Dogger Bank South Wind Farm

Appendix G8 to Natural England's Deadline 8 Submission
Natural England's End of Examination position on Offshore Ornithology

Planning Inspectorate Reference EN010125

3rd July 2025

Figure 1: Mean annual kittiwake collision risk apportioned to FFC SPA for the DBS array areas compared to other offshore wind farms. Figure compiled from data within [REP6-009]. (*Values presented are for the impacts of two array areas.)

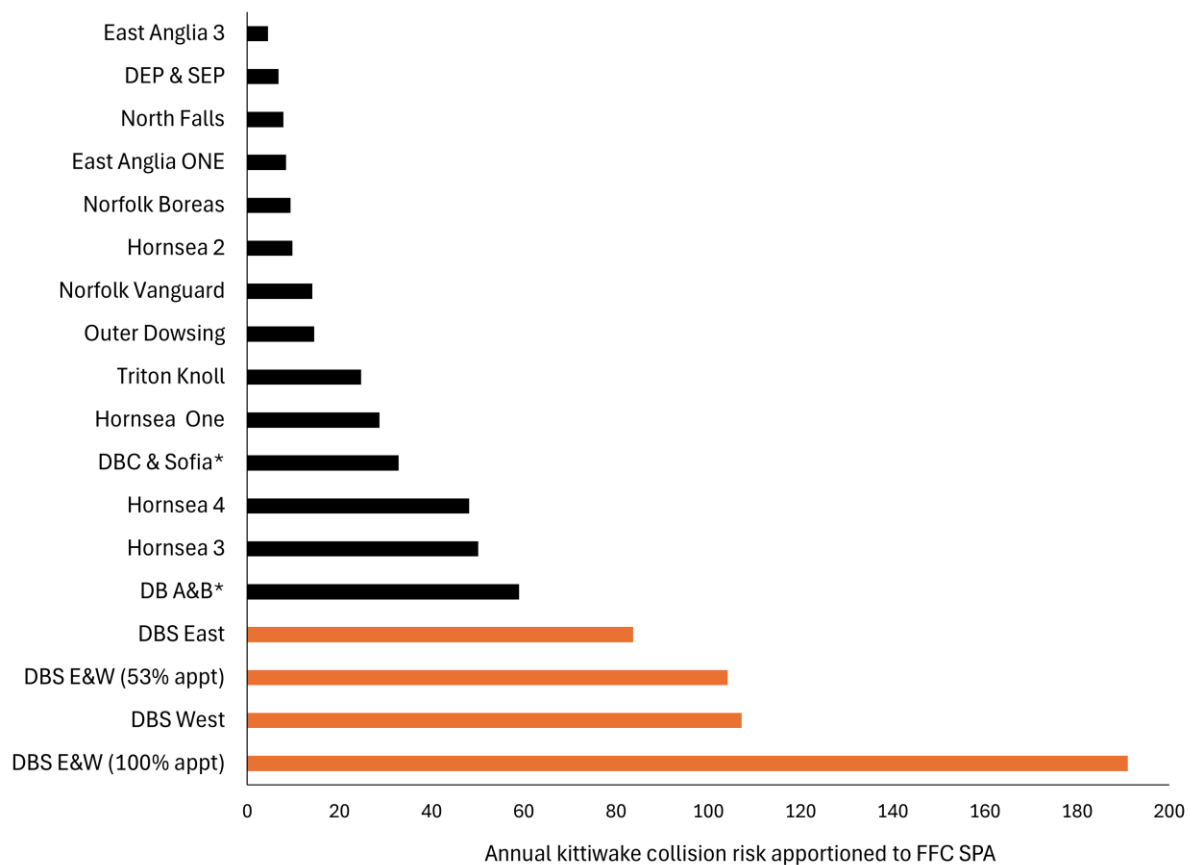
OWF sizes vary and therefore comparisons are not straight-forward, however, DBS is the highest impacting OWF on FFC SPA kittiwake to date, for the Projects both alone and combined (Figure 1). We highlight that the impacts illustrated for DBS East (83.8) and West (107.3) alone in Figure 1 are according to SNCB advised apportioning rates, and therefore are more likely to be comparable with those of the other projects presented. However, were the Applicant's approach to be applied, DBS West (58.3) would remain a higher impact than all other single OWF (the combined impacts of Dogger Bank A&B are 59), and only Hornsea 3 (50.1) and Hornsea 4 (48.1) would have a higher impact than DBS East (45.9).

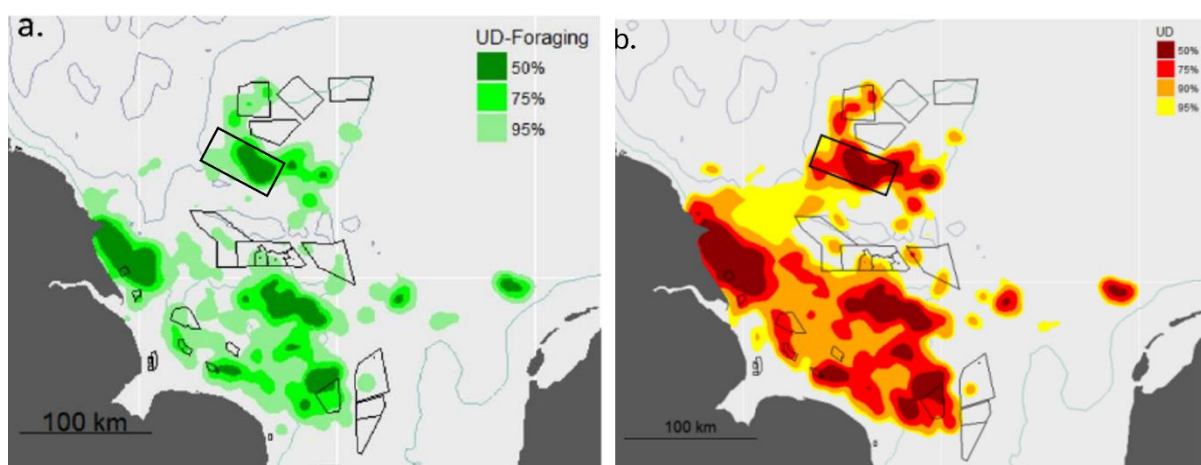
black rectangle has been added by NE and shows the approximate location of the DBS East and West arrays. Figure (b) was previously provided and explained in further detail in our response to ExQ OR.1.39 [REP3-057].

that seabird distributions during the breeding season are constrained to areas within foraging range, and their distribution is also strongly affected by the availability of prey. Given that the Projects (particularly DBS West) are located within areas that are likely to be of high importance for sandeel, and that sandeel are relatively sedentary, Natural England consider that these areas may represent a consistent food source for breeding seabirds. Furthermore, tracking data for FFC SPA kittiwake demonstrates repeated use of areas overlapping with the Projects (Wischnewski et al 2017; Figure 2). We note that if, as the Applicant claims, there are no areas of consistent high usage within the Project areas, then density hotspot modelling would demonstrate this.
